Contract #: 04-0120F4Cty: SF/ALA Rte: 80 PM: 13.2/13.9File #: 69.28**WELDING INSPECTION REPORT****Resident Engineer:** Pursell, Gary**Address:** 333 Burma Road**City:** Oakland, CA 94607**Report No:** WIR-015241**Date Inspected:** 24-Jun-2010**Project Name:** SAS Superstructure**OSM Arrival Time:** 700**Prime Contractor:** American Bridge/Fluor Enterprises, a JV**OSM Departure Time:** 1900**Contractor:** Zhenhua Port Machinery Company, Ltd (ZPMC), Changxing Island **Location:** Shanghai, China**CWI Name:** Li Yan Hua**CWI Present:** Yes No**Inspected CWI report:** Yes No N/A**Rod Oven in Use:** Yes No N/A**Electrode to specification:** Yes No N/A**Weld Procedures Followed:** Yes No N/A**Qualified Welders:** Yes No N/A**Verified Joint Fit-up:** Yes No N/A**Approved Drawings:** Yes No N/A**Approved WPS:** Yes No N/A**Delayed / Cancelled:** Yes No N/A**Bridge No:** 34-0006**Component:** OBG**Summary of Items Observed:**

WELDING INSPECTION REPORT

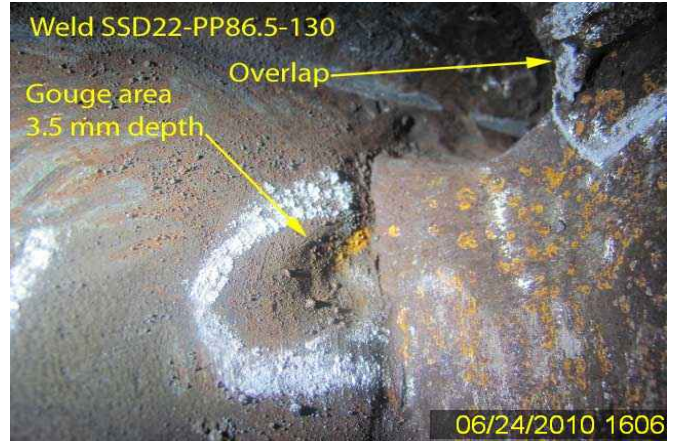
This QA Inspector performed random visual inspection of OBG segment 10AW interior surface. Several areas of base material and welds were covered by debris and required cleaning prior to visual inspection. Areas requiring repair were marked and shown to ZPMC and ABF QC for repair. Please see attached photographs below for additional information.
